**Australian Government**  
**National Capital Authority**

# Consultation Report

## Works Approval No 101565

Demolition of Existing Dwelling and Construction of  
Three Dwellings

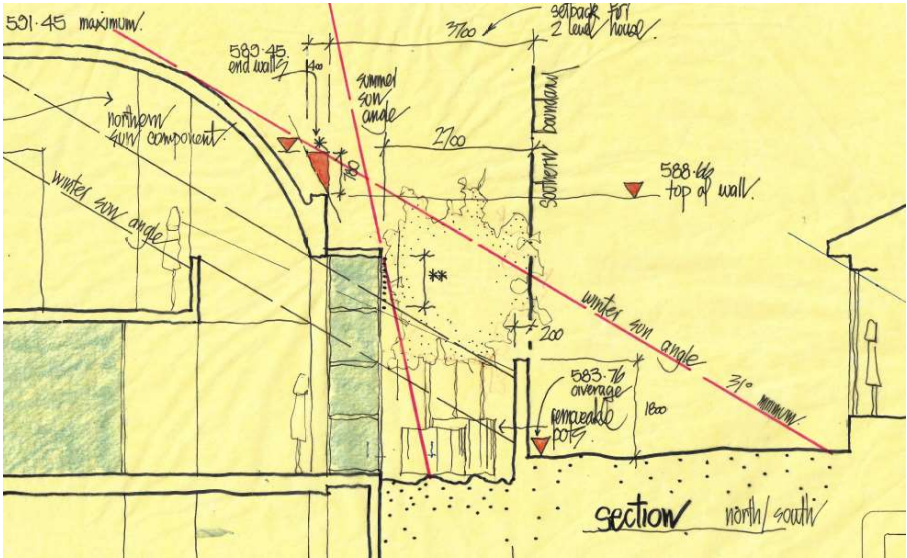
8.3	Overshadowing and loss of privacy for immediate neighbours.	<p data-bbox="1073 829 1955 886">The Part 4.19 of the National Capital Plan (NCP) prescribes setback requirements. The NCP states:</p> <p data-bbox="1129 922 1528 946"><b><u>Building in relation to side boundaries</u></b></p> <p data-bbox="1129 954 1367 979"><b><u>Performance standard</u></b></p> <p data-bbox="1129 987 1835 1044"><i>Requirements for side distances are intended to achieve the following objectives:</i></p> <ol data-bbox="1140 1052 1885 1255" style="list-style-type: none"> <li data-bbox="1140 1052 1885 1101"><i>a. to allow adequate light and ventilation and to preserve the privacy of neighbours</i></li> <li data-bbox="1140 1109 1885 1157"><i>b. in some cases to provide a space wide enough for vehicles to pass by the house on one side at least</i></li> <li data-bbox="1140 1166 1885 1198"><i>c. to provide access for fire control and to inhibit the easy escape of fire</i></li> <li data-bbox="1140 1206 1885 1255"><i>d. to create a spatial separation between detached buildings for reasons of civic design.</i></li> </ol> <p data-bbox="1129 1295 1373 1320"><b><u>Quantitative standards</u></b></p> <p data-bbox="1129 1328 1472 1352"><b><u>Buildings of more than one storey</u></b></p>

NCA also considers that the soft landscape zone is sufficient to provide an adequate landscape buffer/screening, capable of plants reaching full maturity, providing further screening and privacy to neighbours. The buildings, including balconies, do not project into the minimum setback zone of 3m.

Dwelling 3 is setback 3.7m from the southern boundary, with a central building projection setback 3m. The NCA considers that the setback meets the performance and quantitative standards, given there is limited overshadowing and overlooking to the neighbouring dwelling to the south. The applicant provided shadow diagrams, and further information to detail the impact of the proposal on the neighbouring dwelling, see diagram below. The NCA also considers that the soft landscape zone is sufficient to provide an adequate landscape buffer/screening, capable of plants reaching full maturity, providing further screening and privacy to neighbours.

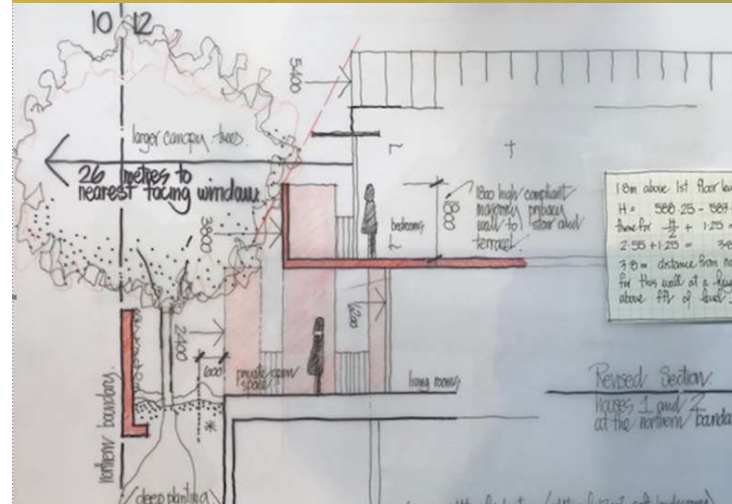
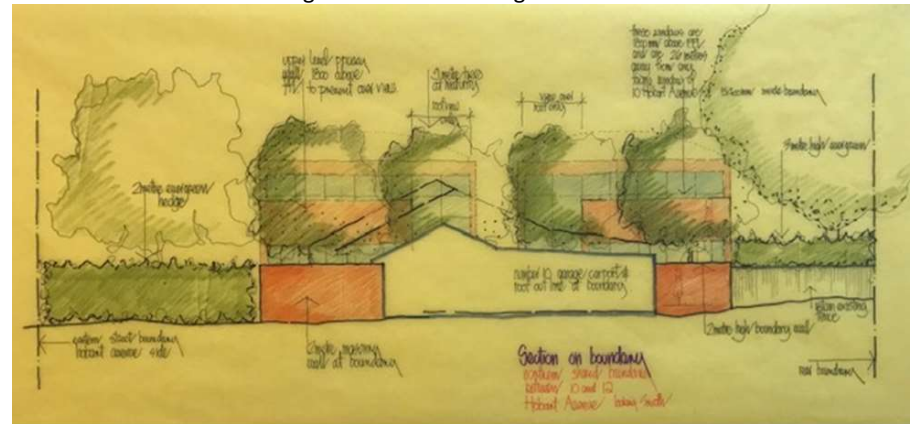
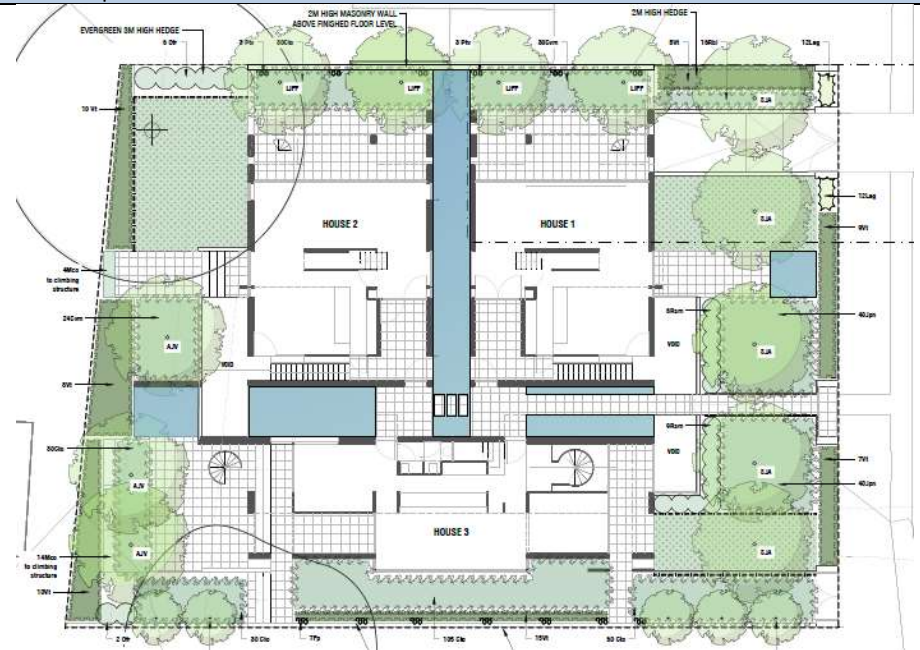
Submission	Comment/Issue	NCA Response
9.4 A	<p><b>Privacy</b> – under the proposed development we always were and continue to be overlooked from height from two dwellings, that is the fishbowl effect.</p> <ol style="list-style-type: none"> <li>The height of the upper level balustrades (1.8m) do not provide sufficient privacy to our home, as many people are 1.8m tall or taller.</li> <li>The balustrades do not extend the full width of the upper balconies, the ‘gaps’ offer free views directly over our home, front and back yards.</li> <li>Inappropriate design for the block size and orientation. We continue to contend that elsewhere in Forrest new multi-dwelling developments have applied a terrace like design, which anchors living to the front and rear of the property, with minimal glass on the side to respect privacy of the property and adjoining street neighbours. The development does exactly the opposite, and worse, two of the three dwellings are not only anchored to the boundary we share, the northern walls of these two dwellings are floor to ceiling glass on both levels.</li> <li>The excessive use of transparent glass – floor to ceiling east to west of the upper northern façade amplifies the fishbowl effect. A northern wall of glass on the second storey of two (of the three) dwellings is flagrantly inconsiderate to us as immediate neighbours with an existing single level home.</li> <li>Deciduous trees along the northern boundary (four white crepe myrtles) are not dense in foliage and purely ornamental, they are not capable of providing any shade or boundary privacy.</li> </ol> <p>Trees are purely for landscaping and cannot remedy building design failures and inadequacies, such as privacy and lighting concerns.</p> <p>Landscaping and vegetation can never solely address privacy concerns given their potential temporary nature. For example, should the proposed plantings be cut down (intentionally or otherwise), the NCA does not have the enforcement capabilities to require them to be</p>	<p>Following the meeting on 16 December 2019 further information (additional shadow diagrams, northern and southern elevations) was provided by the applicant on 20 and 23 December 2019. Refer to the sketches below. The NCA provided this information to adjoining neighbours on 23 December 2019.</p> <p>The NCA considers that the proposed and existing landscaping (including the proposed 2m solid wall on boundaries) will provide privacy to 10 and 14 Hobart Avenue.</p> <p>The eye level of an average person does not exceed 1.8m in height. The small ‘gap’ within the balustrade articulation will limit overlooking due to the balustrade fin walls that extend beyond the main façade of the building that also provide privacy between the dwellings themselves. Refer to the 3D image below.</p>  <p>In addition to the building design, the dwelling is setback 5.4m from the northern boundary to allow a sufficient landscape buffer for additional screening and privacy purposes (refer to the sketches below that indicate trees and hedging). The trees proposed to the northern boundary are required (by the NCA) to be deciduous and contribute substantial shade in summer. The Crepe Myrtle variety specified by the registered landscape architect is supported by the NCA and is capable of reaching a height of 9m with a canopy of 8m. The species also displays a dense array of</p>

ornamental branches which will also assist in maintaining privacy in winter, in addition to the solid 2m wall and evergreen Viburnum hedge.

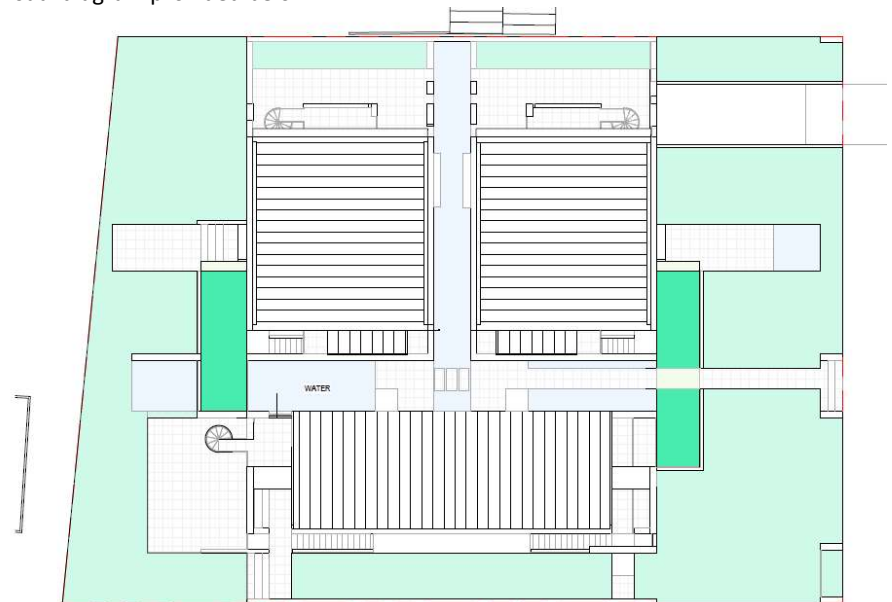
11.7	it has limited greenery for such bulk and height	The soft landscape ratio is correct (in accordance with the definition outlined in the Guidelines) and complies with the requirement of 40%. This includes trees, shrub species, groundcovers, climbing species and irrigated turf.
------	--------------------------------------------------	-------------------------------------------------------------------------------------------------------------------------------------------------------------------------------------------------------------------------------------

Visual diagram provided below.

A landscape plan has been provided with the application. The design has been prepared by Harris Hobbs Landscape Architects.

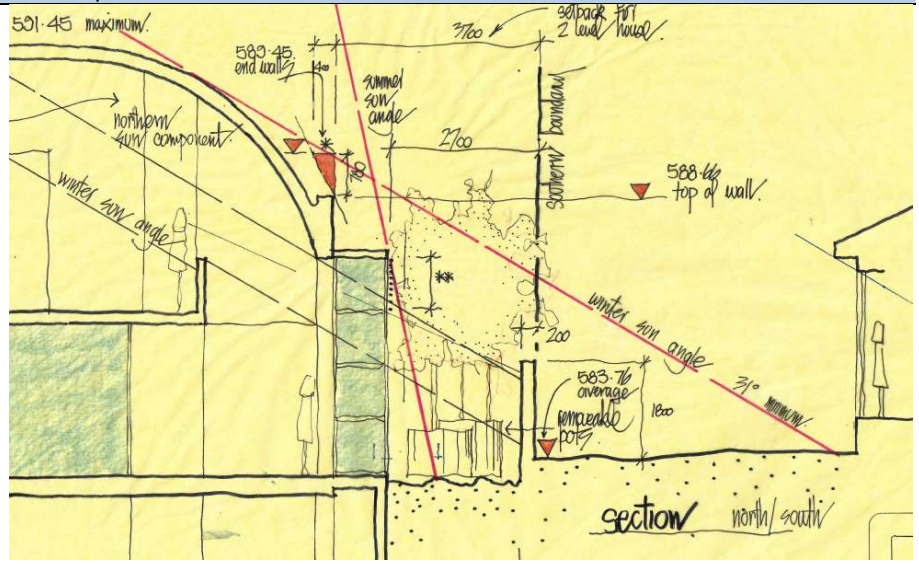
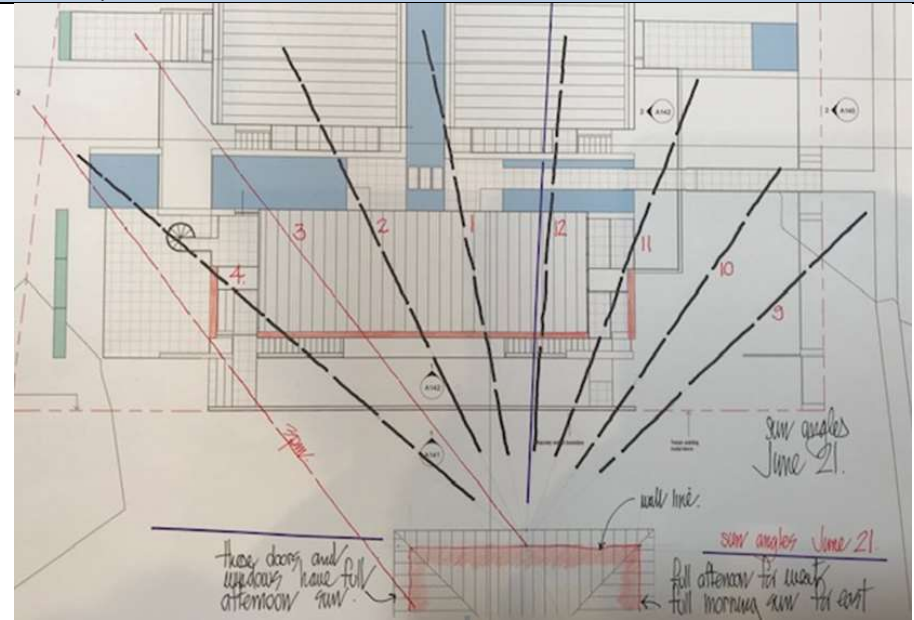
Submission	Comment/Issue	NCA Response
	<p>Such blatant nonchalant unresponsiveness to the identified overshadowing, highlights and evidences the proposal's indifference to such significant negative impact on neighbouring amenity.</p> <p>A penetrating glimpse of the bleeding obvious reveals the identified overshadowing as of nil import - to the proposal's intent. That being: the maximising, optimising, capturing, and consumption of every nano-skerrick of benefit - in the proposal's sole interest.</p> <p>That being: to the extreme detriment of my property and amenity.</p> <p>Such lackadaisical blasé offhanded unresponsiveness disregards utterly such significant overshadowing. The application fails to address or propose remedy for such negative design and placement outcome.</p> <p>For example: recording a static noon 21 June overshadowing impact, the ground level illustrates a lowered ground level of House No. 3, to that of the adjoining property. There is no indication that Block ground levels are accurate. There is no documentation provided to indicate that the Block has been surveyed or that the overall application measurements are reliable.</p> <p>Furthermore, the extensive overshadowing prohibits further possible development opportunity on my property and particularly on my north thus severely reducing my amenity and also the potential value of my property.</p> <p>I also hold concerns regarding the negative impact on the installation of planned additional solar panels/batteries to my property north to enhance my solar and sustainability capacity.</p> <p>A full analysis of the significant overshadowing of my property is required to assess the full extent of shade thrown by House No. 3, over the extended</p>	<p>Dwelling 3 during the equinox to a greater extent than the existing boundary fence (Spring and Autumn).</p> <p>There will be no shadows cast onto any windows or habitable rooms or principal private open space areas at noon on the winter solstice.</p> <p>On 21 June between the hours of 9am and 2pm there are no shadows cast onto any windows, habitable rooms or principal private open space areas. Larger shadows are cast around the hour of 3pm and after. It is around this time that the sun has moved further from the north to the west and has a low altitude of 18 degrees, making windows facing west more desirable for sun penetration than northern windows.</p> <p>The NCA considers that there will be limited overshadowing to 14 Hobart Avenue as a result of the proposal at 12 Hobart Avenue, based on the above criteria. The limited overshadowing during the late afternoon on the winter solstice is not unreasonable as there will be direct sunlight to the property between the hours of 9am and 2pm (minimum 5 hours). At other times throughout the year, the hours for direct solar access will increase.</p>

Submission	Comment/Issue	NCA Response
	<p>Canberra winter period. In particular the winter solstice shadowing diagrams provided fail to indicate the shadowing impact to the roof areas.</p> <p>I have renovated my property extensively to capture and maximise the northern sun/light and warmth to the home and gardens. My entire north and west is ceiling to floor windows with access to the attached outdoor terraced living areas. That amenity – my living areas currently bathed in full winter sun and warmth – is severely compromised.</p> <p>I am personally devastated at the prospect of the consequence of my loss of northern sun, light, and warmth.</p> <p>My existing privacy to such areas is also severely compromised.</p>	 <p>The diagram is a hand-drawn architectural section on yellow paper, labeled 'section north/south'. It shows a cross-section of a building with a curved roofline on the left and a vertical wall on the right. Key annotations include: <ul style="list-style-type: none"> <li>'591-45 maximum!' at the top left.</li> <li>'583-45 end wall?' with a vertical dimension line.</li> <li>'7700' and '2700' as horizontal dimensions.</li> <li>'setback 2 lead house!' at the top right.</li> <li>'summer sun angle' and 'winter sun angle' indicated by red lines.</li> <li>'northern sun component' and 'winter sun angle' with arrows pointing to the roof.</li> <li>'588 top of wall.' with a vertical dimension line.</li> <li>'583-76 average removable pot?' with a vertical dimension line.</li> <li>'370 minimum' at the bottom right.</li> <li>'section north/south' at the bottom right.</li> </ul> </p>

The proposal will not cast a shadow at any time to the roof of the dwelling at 14 Hobart Avenue and will not impact solar access to the solar panels.
